Addendum Date: February 17, 2023

CITY OF PENSACOLA, FLORIDA
ADDENDUM #1

BERTH 6 REHABILITATION PROJECT

BID NO: 23-013

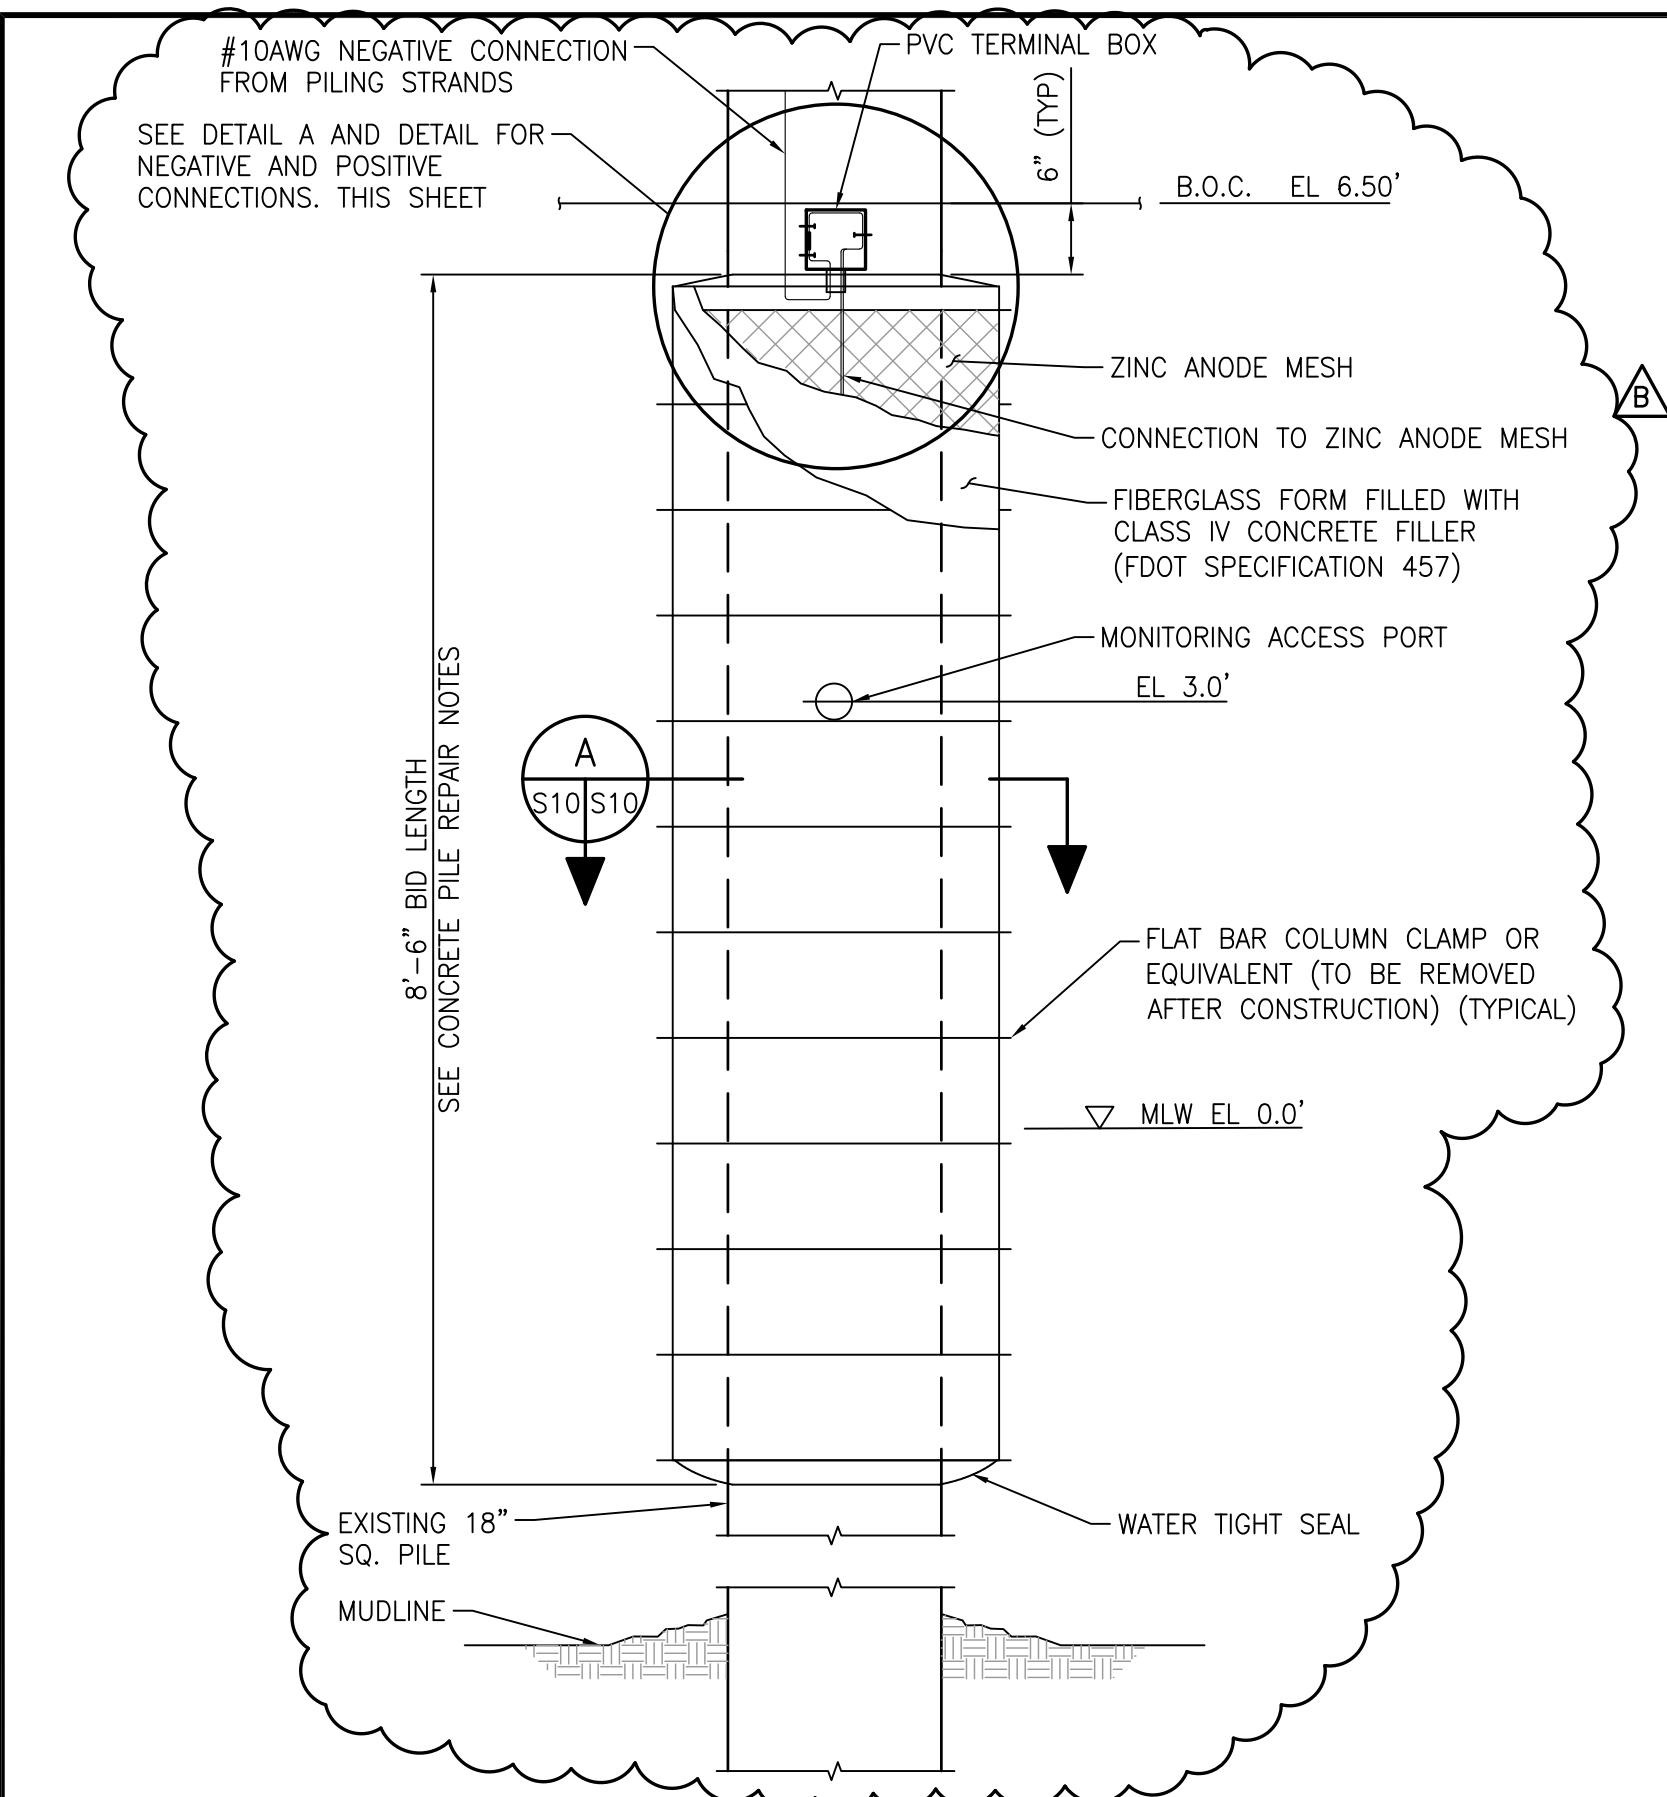
- d. Berth 6 Rehabilitation Project drawing S26 detail A calls for “EXISTING SUBGRADE COMPACTED TO 95% MODIFIED PROCTOR (ASTM D1557)” to a depth of 7’4” adjacent to the new compacted subgrade placed with an approximate 1:1 slope. Please advise if this is intended to advise the contractor that the existing subgrade is already properly compacted or if the contractor is to bench the existing subgrade and test the compaction of the existing subgrade. Further, if the existing subgrade does not meet the required compaction, please advise what steps the contractor is to take to correct the compaction of the existing.

The disturbed existing subgrade shall be compacted as stated prior to installation of the new subgrade. Benching is not necessary.

CONCRETE PILE REPAIR DETAIL
3/4"=1'-0"

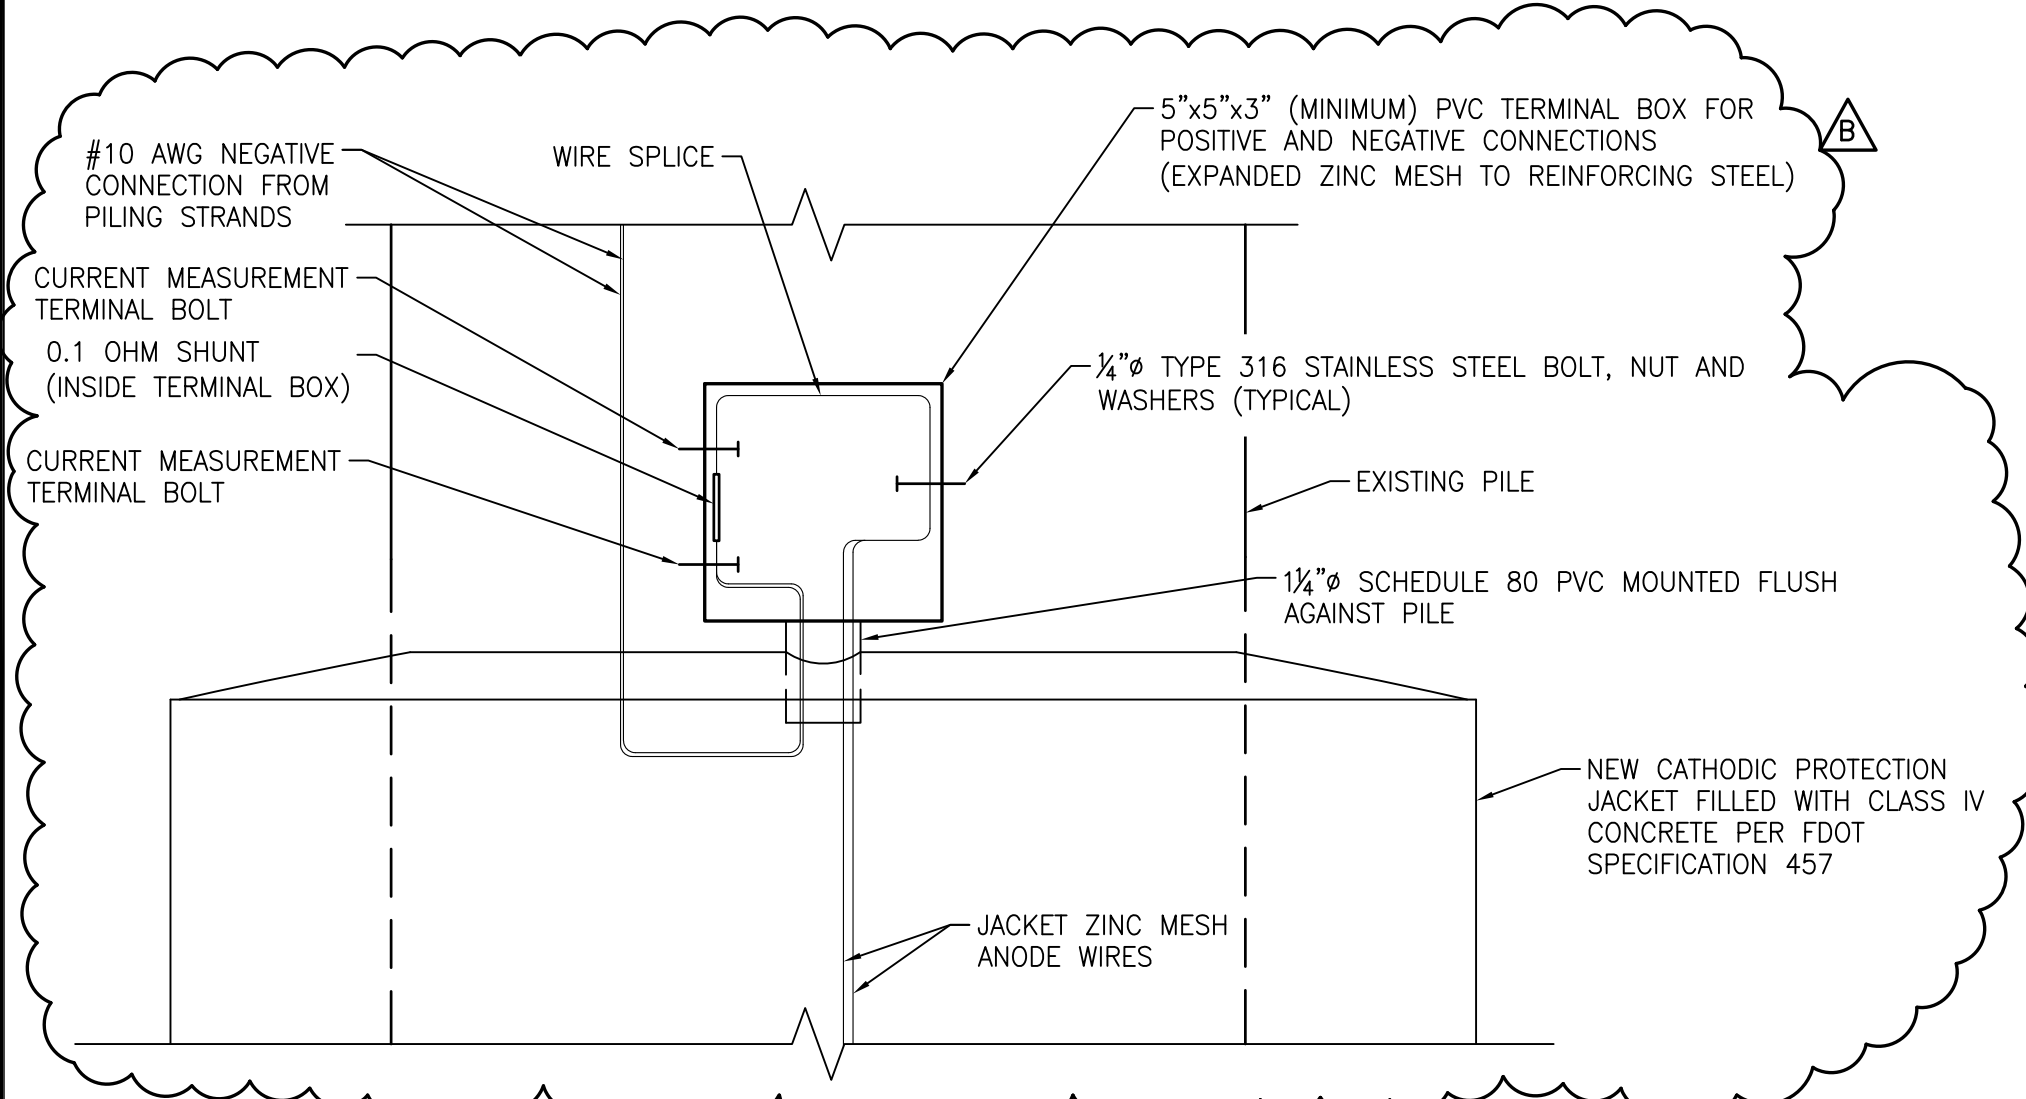
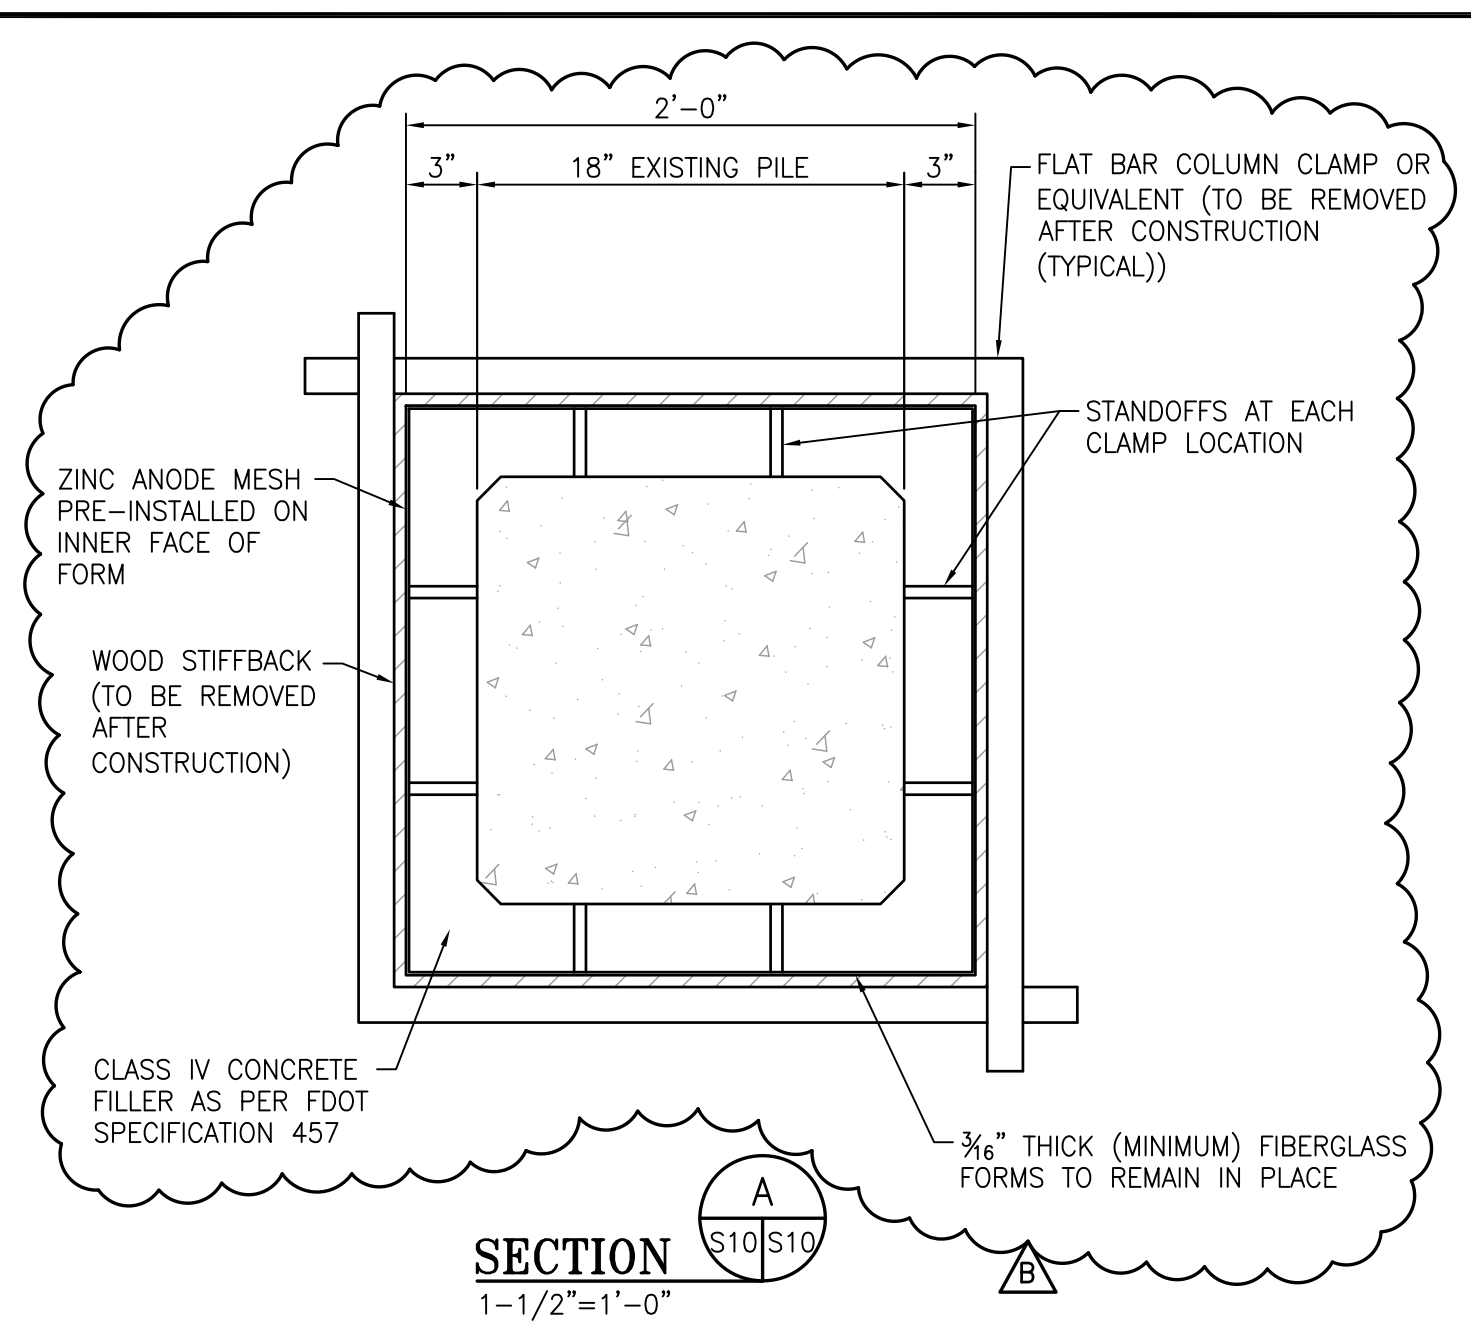
- PILE REPAIR SYSTEM SHALL BE A CATHODIC PROTECTION STRUCTURAL INTEGRAL PILE JACKET SUCH AS LIFEJACKET ANODE SYSTEM MANUFACTURED BY STRUCTURAL TECHNOLOGIES OR ENGINEER APPROVED EQUAL. SEE PROJECT SPECIFICATION 13120 GALVANIC CATHODIC PROTECTION JACKET SYSTEM. SUBSTITUTION OF REPAIR SYSTEM SHALL BE ENGINEER APPROVED PRIOR TO BID.
